2019 GROUP B PROPOSED CHANGES TO THE I-CODES ALBUQUERQUE COMMITTEE ACTION HEARINGS

2018-2019 Code Development Cycle, Group B (2019) Proposed Changes to the 2019 *International Codes*

FIGURE 1608.2
GROUND-SNOW LOADS, p_g, FOR THE UNITED STATES (psf)

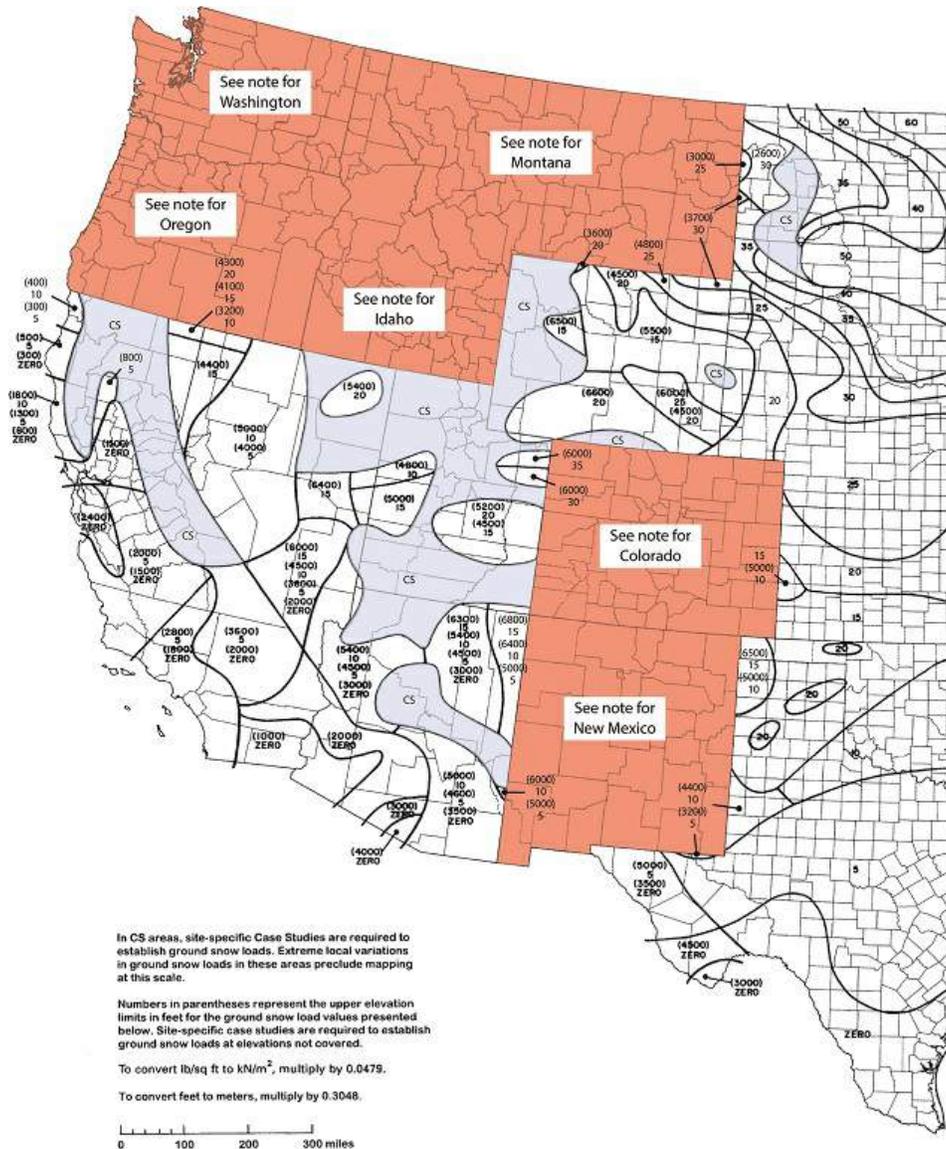
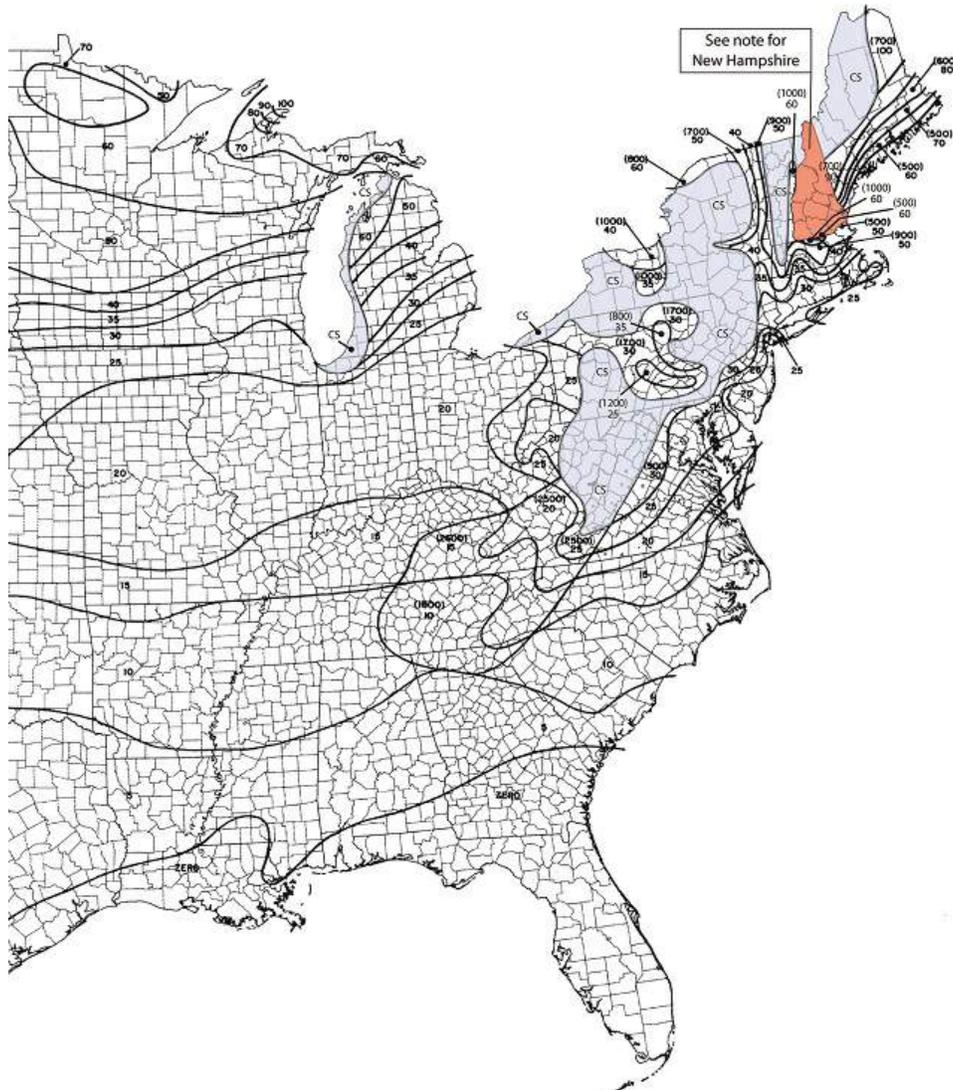
IBC: FIGURE 1608.2

Proponent: Jennifer Goupil, American Society of Civil Engineers (ASCE), representing American Society of Civil Engineers (ASCE) (jgoupil@asce.org)

FIGURE 1608.2
GROUND SNOW LOADS, p_g , FOR THE UNITED STATES (psf)

FIGURE 2303.4.1.2.(2b) ALTERNATIVE INSTALLATION USING BUCKLING REINFORCEMENT FOR TRUSS WEB MEMBERS IN LIEU OF TWO ROWS OF PITMR

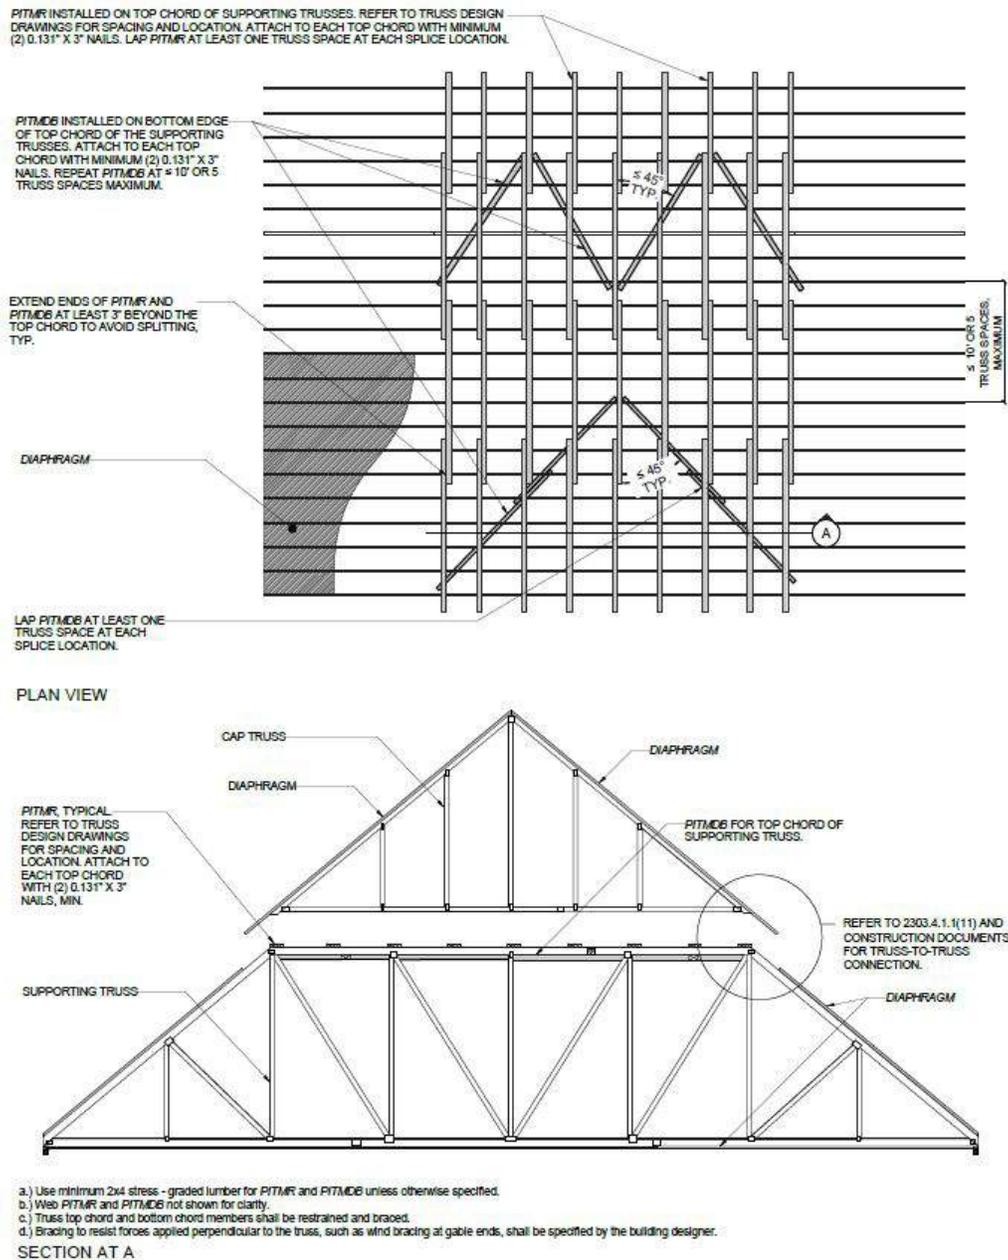
2303.4.1.2

FIGURE C301.1

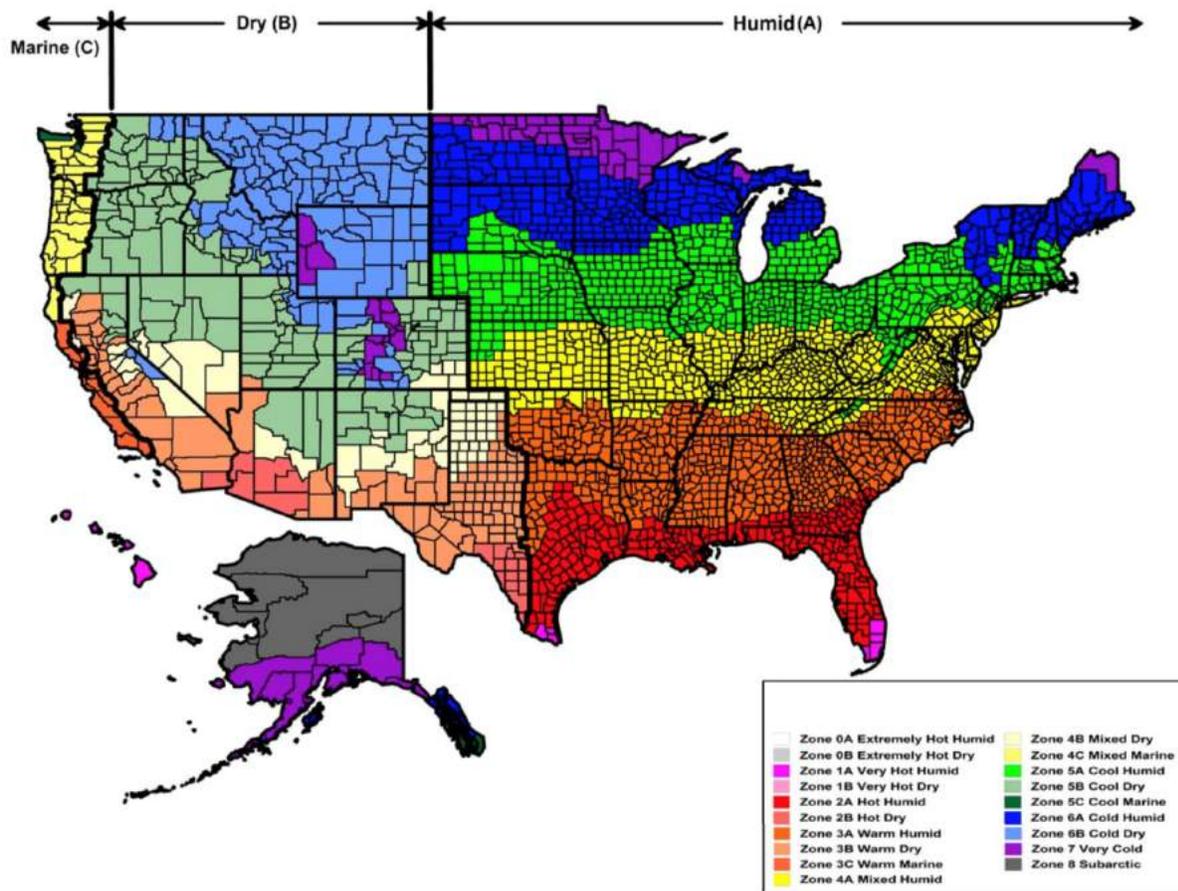
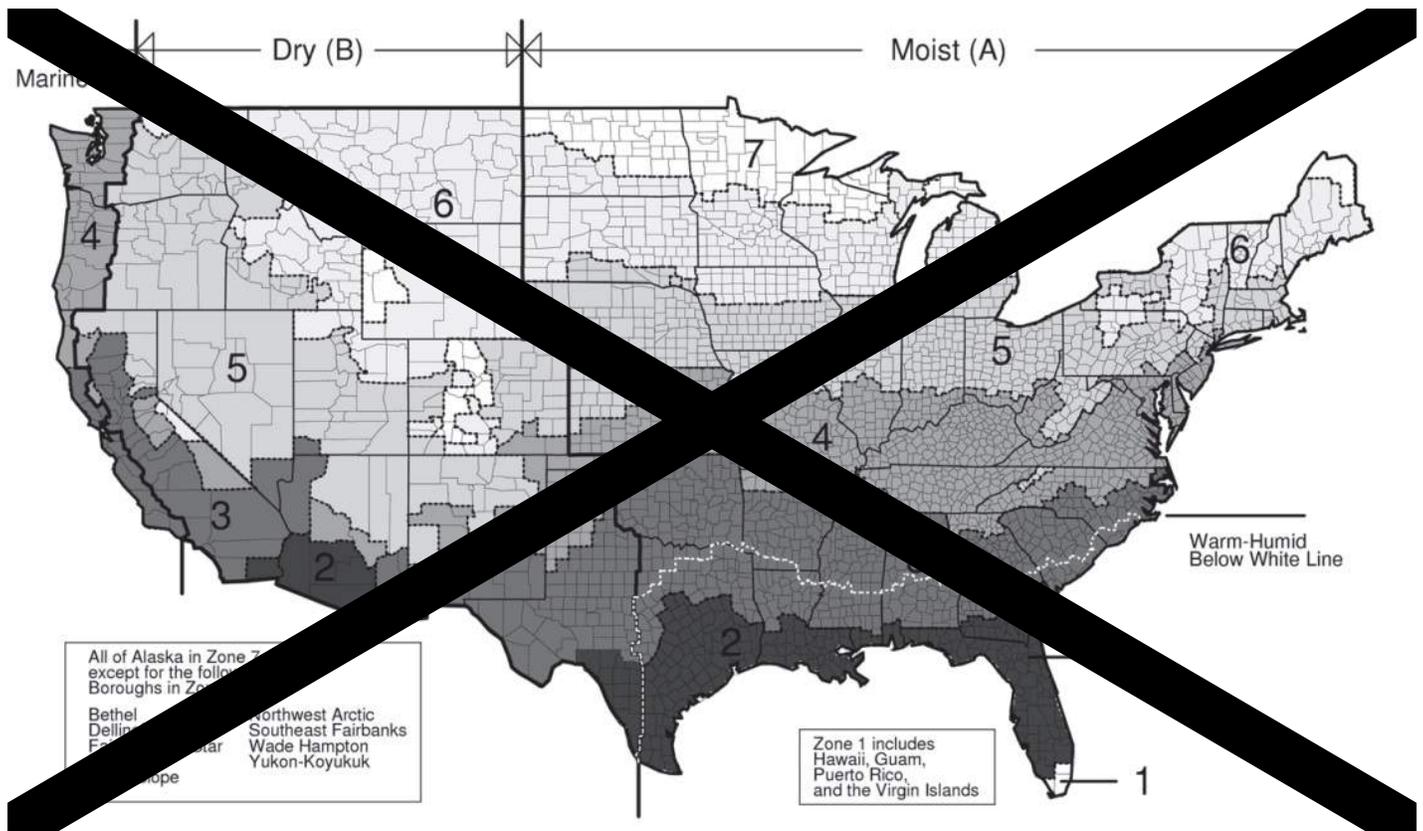
Revise as follows:

FIGURE C405.2.3.2
PRIMARY AND SECONDARY SIDELIT ZONE

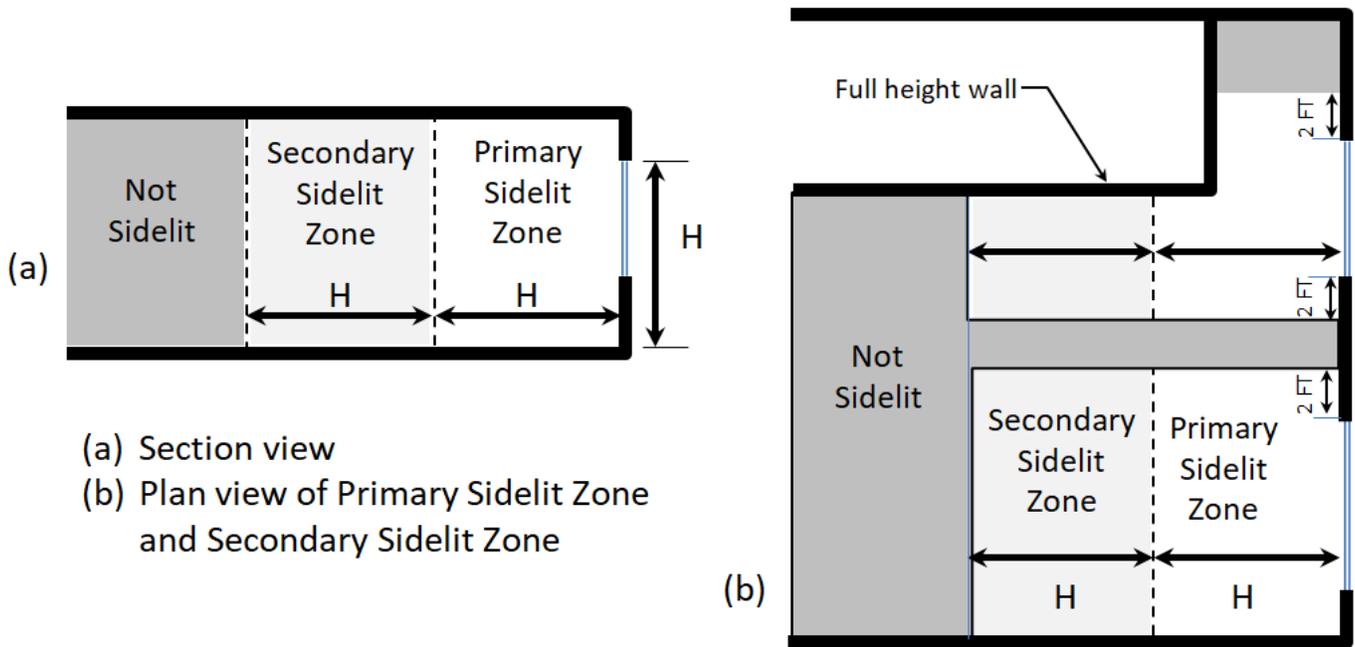
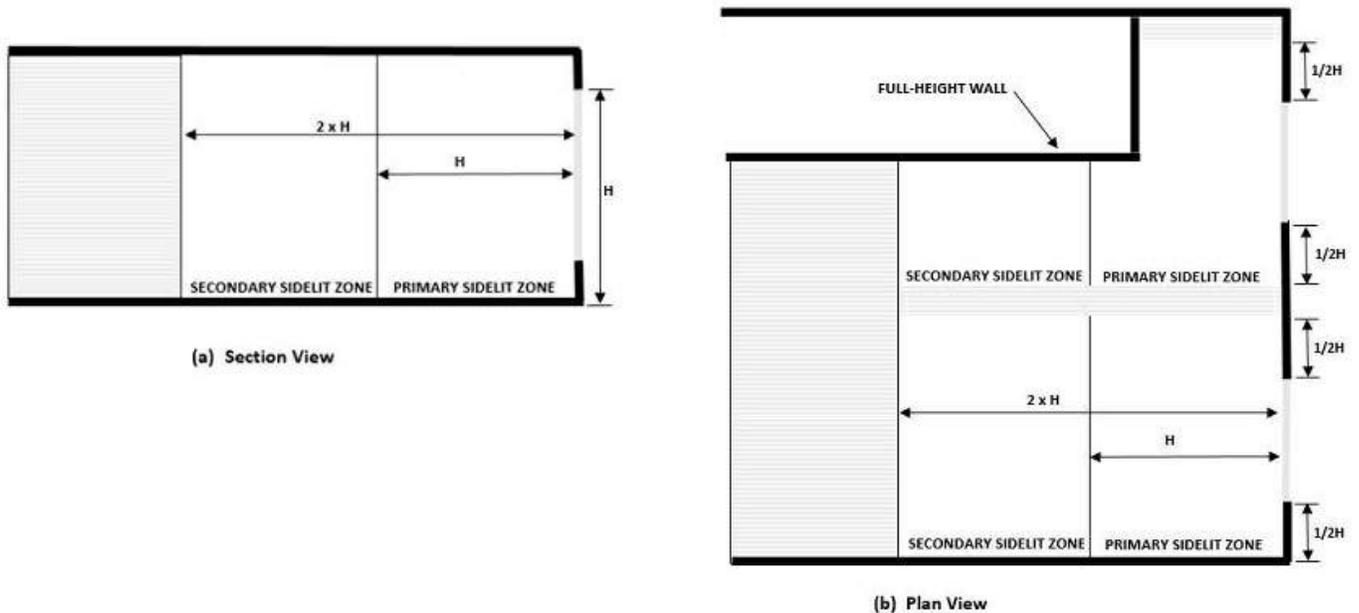
**FIGURE C405.2.3.2
SIDELIT ZONE**

FIGURE C405.2.3.2
SIDELIT ZONE

FIGURE R301.2(2) - continued
SEISMIC DESIGN CATEGORIES

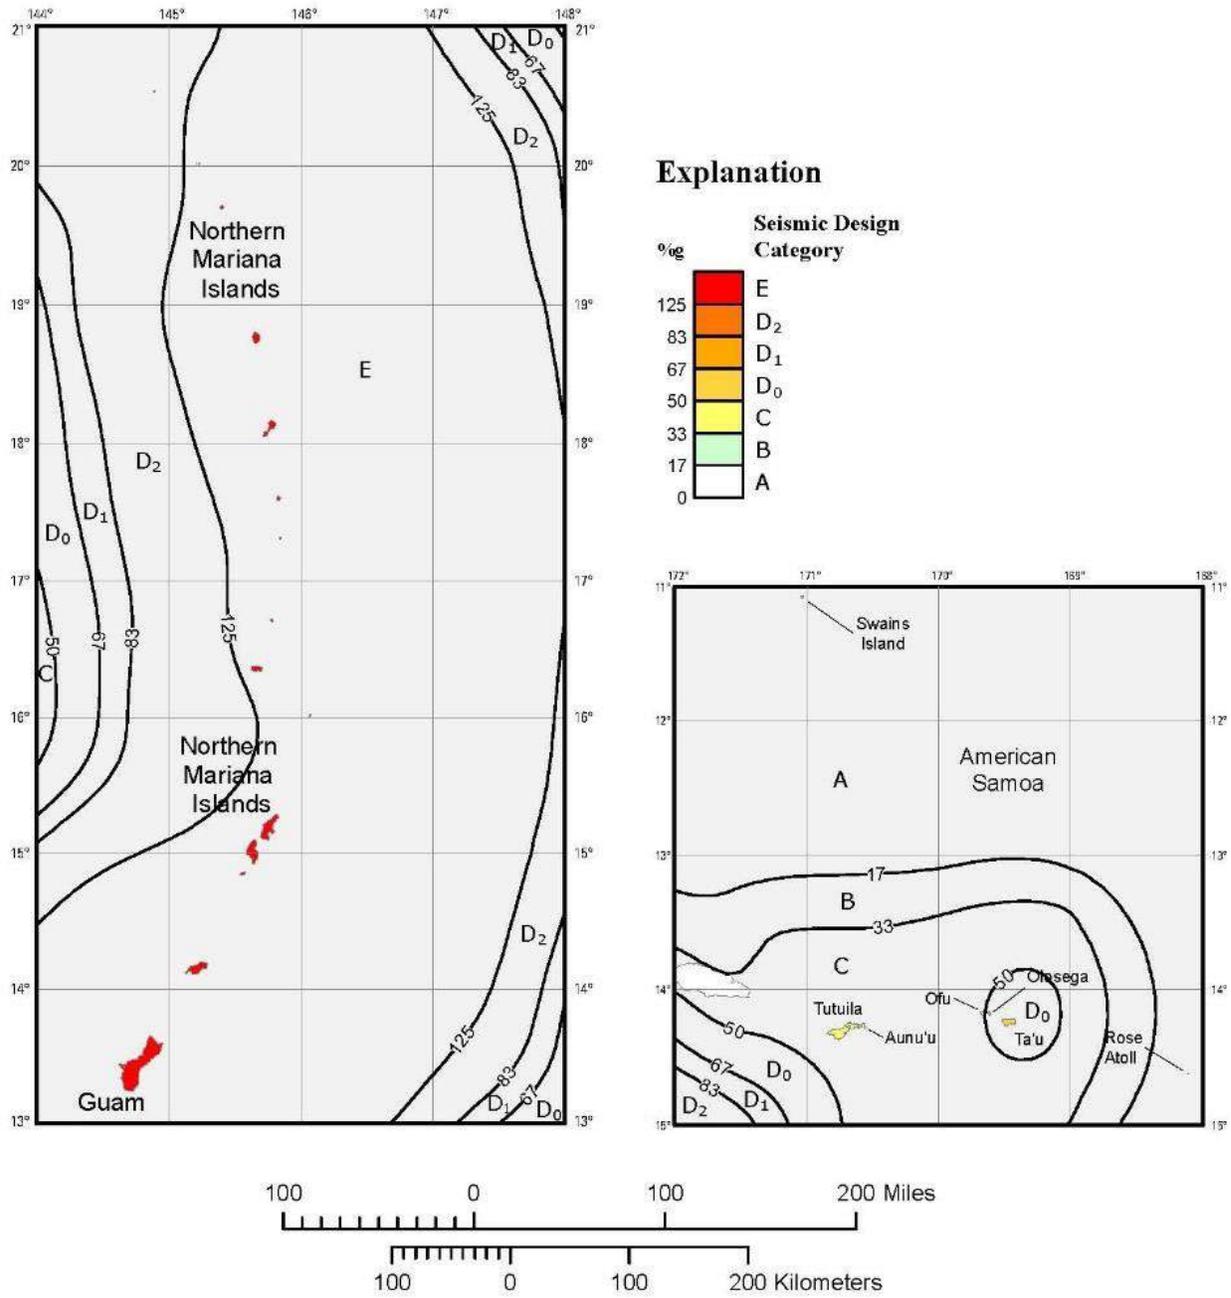
Revise as follows:

FIGURE R301.2(5)B
REGIONS WHERE WIND DESIGN IS REQUIRED

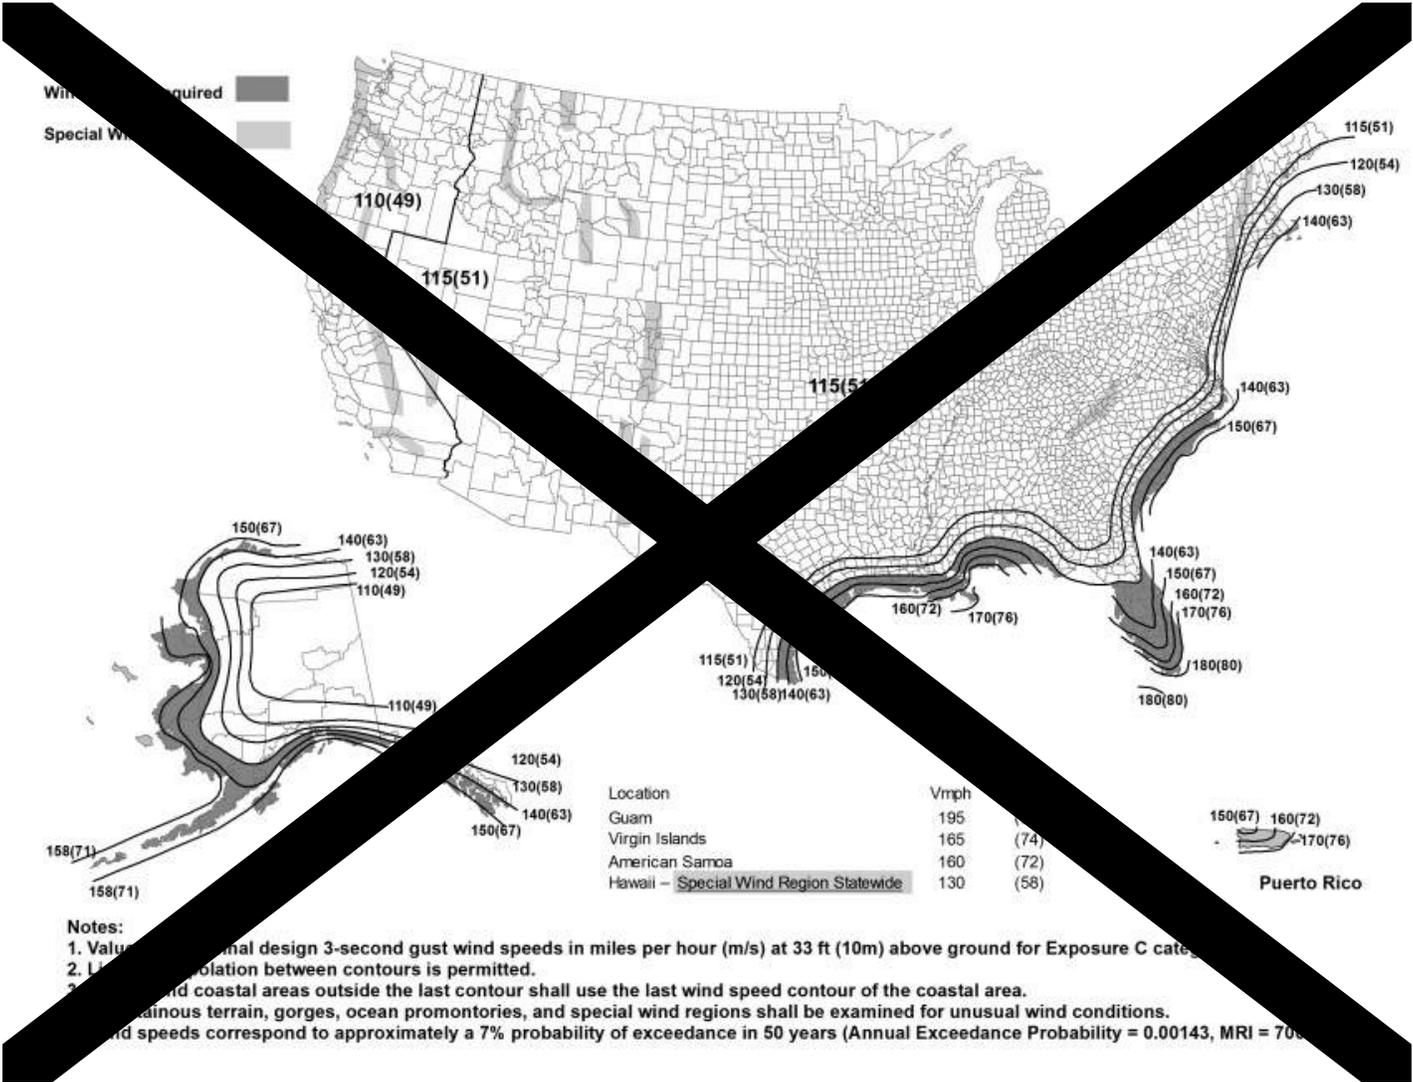
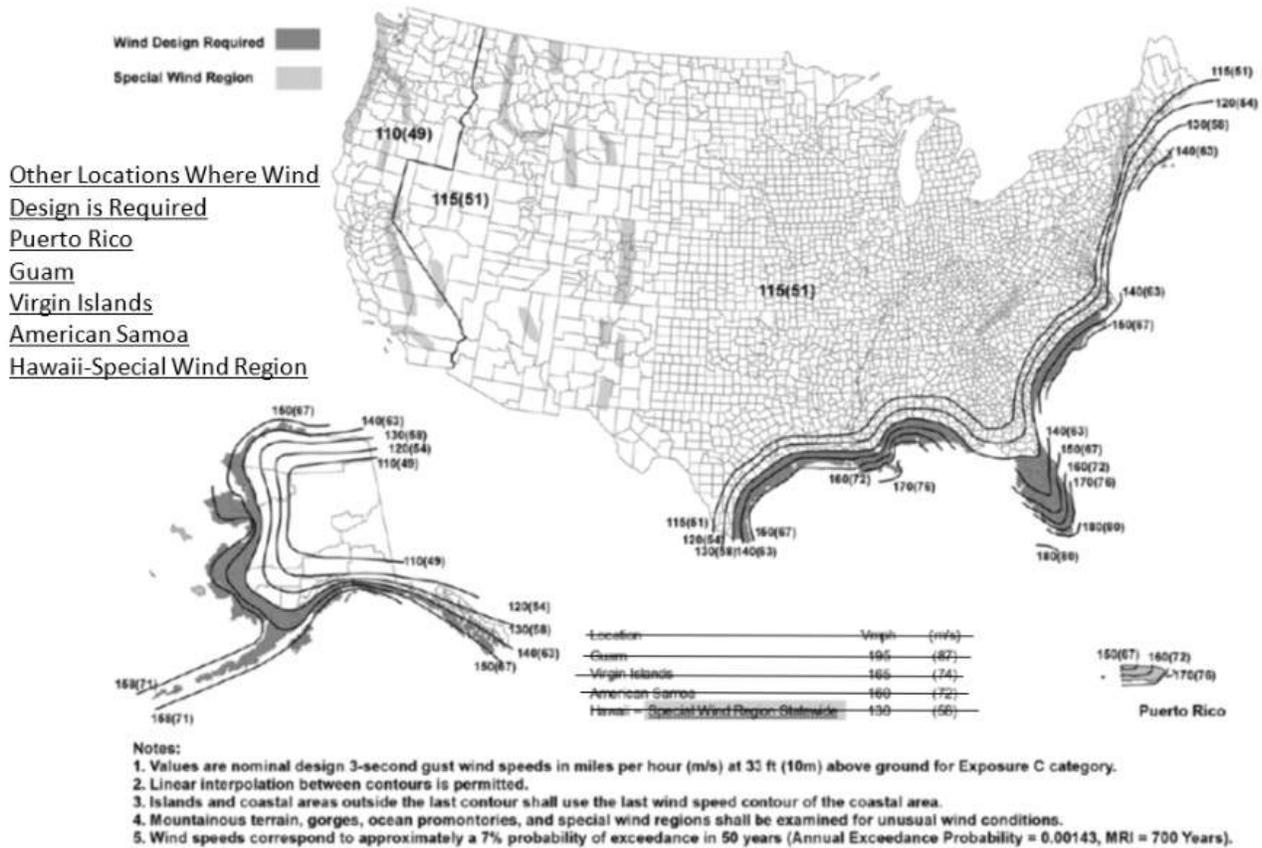
Revise as follows:
